February 25, 1983

Enclosed you'll find a version 2.0 ROM for your ATR8000. This ROM has added new features to the ATR8000 along with some improvements. This ROM has been shipped to you free of charge. All we ask is that you return your old ROM so that we can keep you on our Customer Update List.

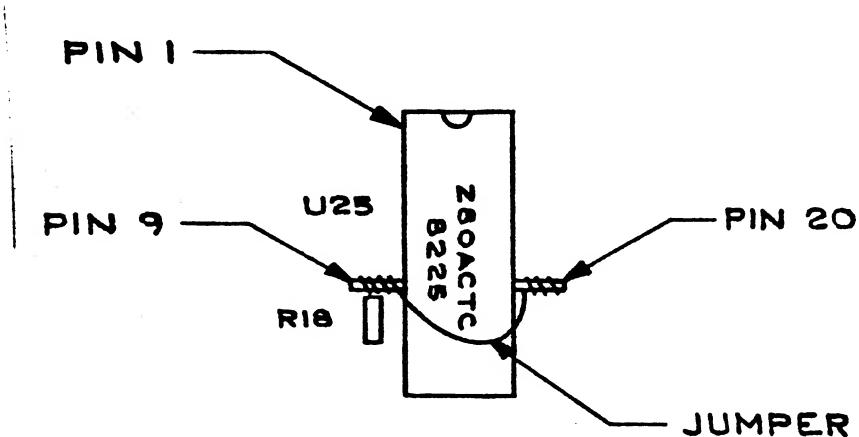
- 7) The 2.0 ROM will run flipped over disks with no index holes (we do not recommend this practice). It will also run hard sector disks that have been reformatted with a soft sector format.
- 8) We have implemented an abort timer on the CTC that eliminates possible disk controller lockup situations. To do this alteration, follow one of these two procedures. (If your unit was shipped with a 2.0 ROM, ignore this item.) We recommend the first procedure.

Remove the Z80A CTC chip from the socket. This can be done by gently prying it out of the socket using a small flat blade screwdriver. The diagram below shows this chip.

Find Pins 9 and 20 on the chip. Use the diagram for reference. Bend these pins' leads straight out to the sides as shown. Using the small piece of 30 gauge wire (from SWP), connect these two pins together as shown. It

is best to solder the wire ends to the pin leads. If you do not have access to a soldering iron, then carefully wrap the ends of the wire around the leads, making several loops around each lead.

Put the chip back in the socket, making sure to replace it so that it is oriented as it was before (i.e., Pin 1 is in the proper location).
